**Komunikacijski sistemi za števce - 2. del: Žične komunikacije po M-vodilu -
Dopolnilo A1**

DRAFT
EN 13757-2:2018
prA1

Communication systems for meters - Part 2: Wired M-Bus communication

This draft amendment is submitted to CEN members for enquiry. It has been drawn up by the Technical Committee CEN/TC 294.

Replace the image of Figure 1

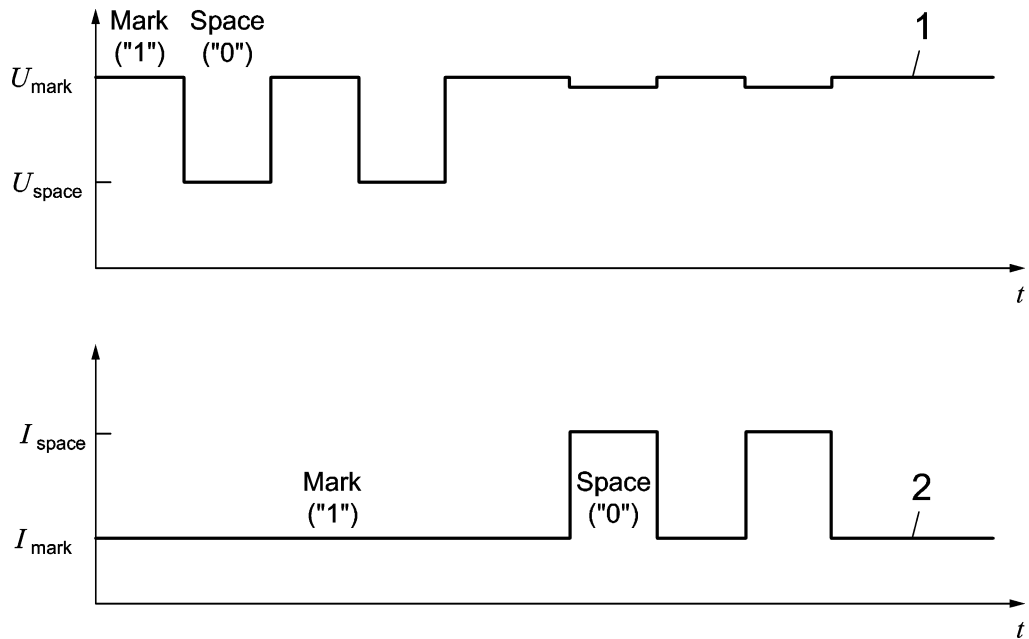
9 Modification to Figures 1 to 7

with the following:
